# SERVICE BULLETIN No.1177

<b>COACH BUS MODEL</b>	: T2145 and C2045
<b>BULLETIN TYPE</b>	: Product Improvement
<b>SECTION</b>	: Maintenance Manual: Chapter 10 - HVAC
<b>DATE</b>	: December 19, 2005
<b>SUBJECT</b>	: <b>Proheat M80 coolant pump hook-up</b>
<b>TERMS &amp; CONDITIONS</b>	: No claims will be accepted with reference to this Bulletin.

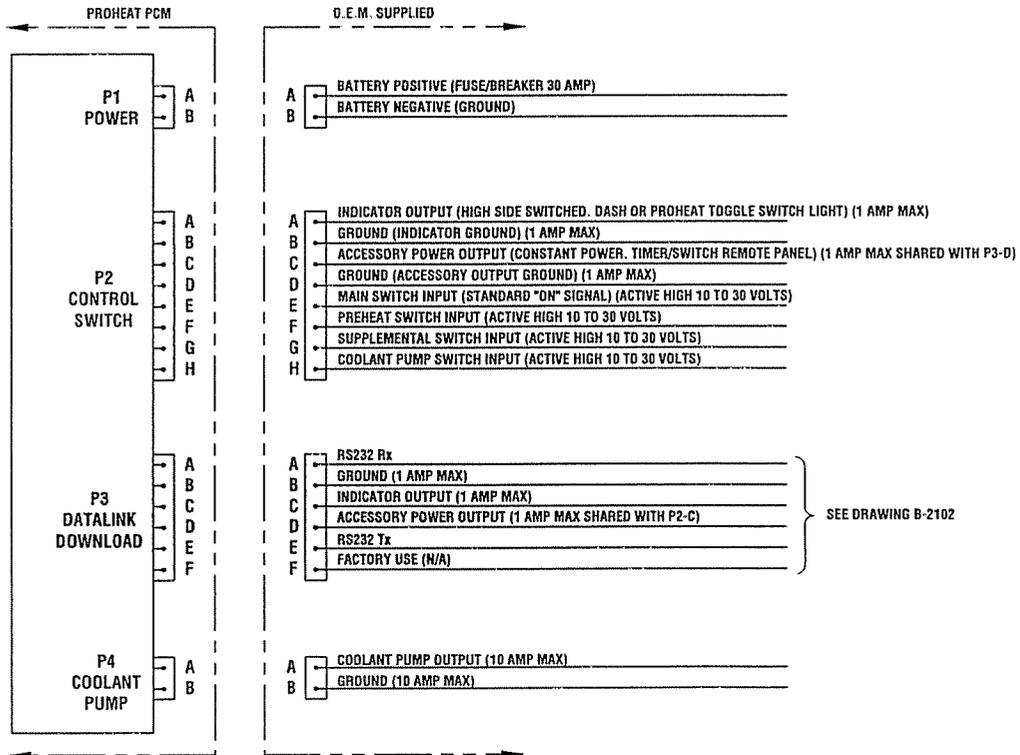
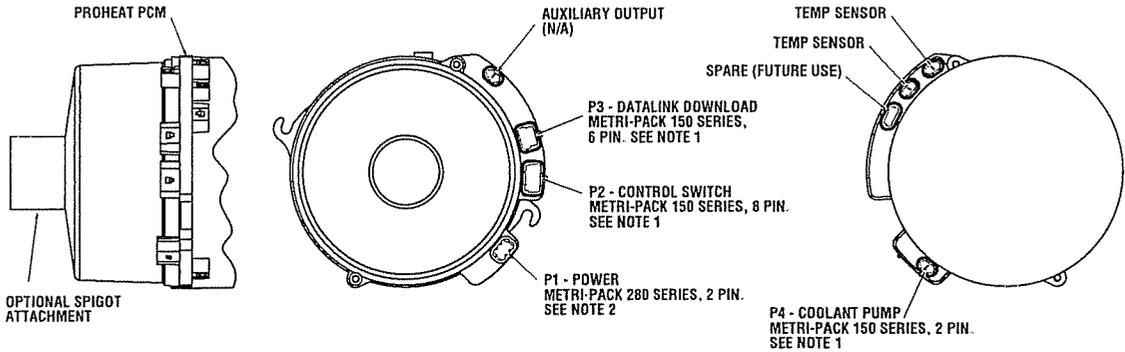
1. With the previous hook-up, the coolant pump stopped working when the auxiliary heater went into failure mode (e.g. loose connection at the overheat sensor).
2. To address the issue a jumper wire has been installed between pin E and pin H of connector 2 of the Proheat ECU (see overleaf).  
On production coaches this wiring change has been made in the main junction box.  
On field coaches the jumper wire can be installed at the Proheat P2 connector (see Figure 3).  
Owners and operators wishing to apply this Product Improvement on their coaches, can refer to the procedure in this Bulletin for retrofit instructions.
3. Pump operation with the new wiring is as follows:

C2045 units: The pump will start working from the moment the auxiliary heater is being switched on. Pump operation control is through Sytronic 2.

T2100 units: The pump will start working from the moment the auxiliary heater is being switched on. Pump operation control is through the multiplex system.

**Figure 2: Proheat M80 control connector P2 (C2045 production unit)**

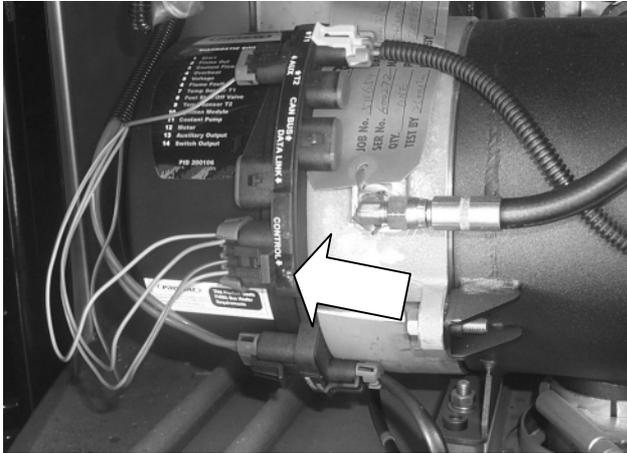
- 1) Open the auxiliary heater compartment door and locate Proheat control connector P2 (see Figure 2).

**Figure 3: P2 connector terminal location (rear view)**

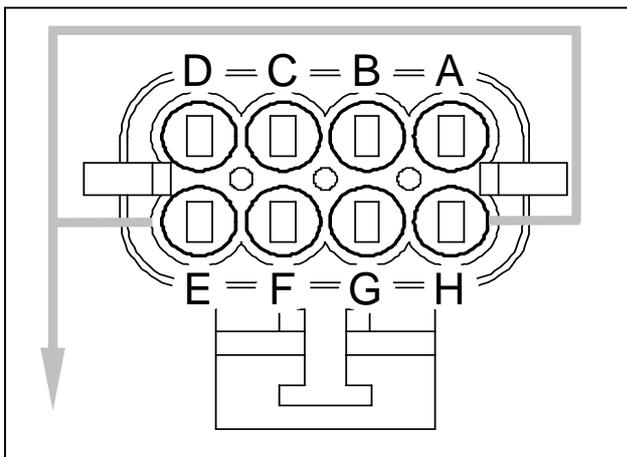
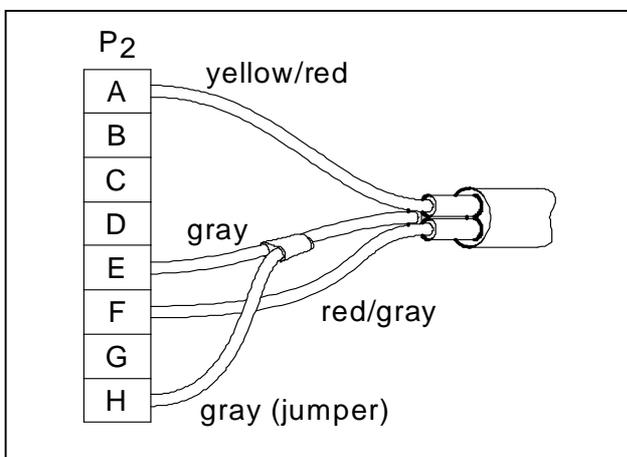
- 2) Lift the catch and withdraw the connector from the heater ECU. Lift the protective cap from the back of the connector.
- 3) Locate the gray wire that is installed in terminal opening #E (see Figures 3 and 4). At approximately 2 inches from the connector, cut the gray wire. Strip both ends of the wire and prepare them for soldering.

A = yellow/red wire  
F = red/gray wire  
E and H = gray wire

- 4) Slip heat shrink sleeve over the wire.
- 5) Join the jumper wire and the stripped wires by soldering.
- 6) Slip the sleeve over the soldered joint and shrink it.
- 7) Remove the cavity seal from connector terminal opening #H.  
Insert the jumper wire terminal in opening #H.  
Check that the jumper wire seal fits properly in the connector.
- 8) Refit the protective cap.
- 9) Reconnect connector P2 to the heater ECU.
- 10) Check the auxiliary heater's operation.
- 11) Close the heater compartment door.
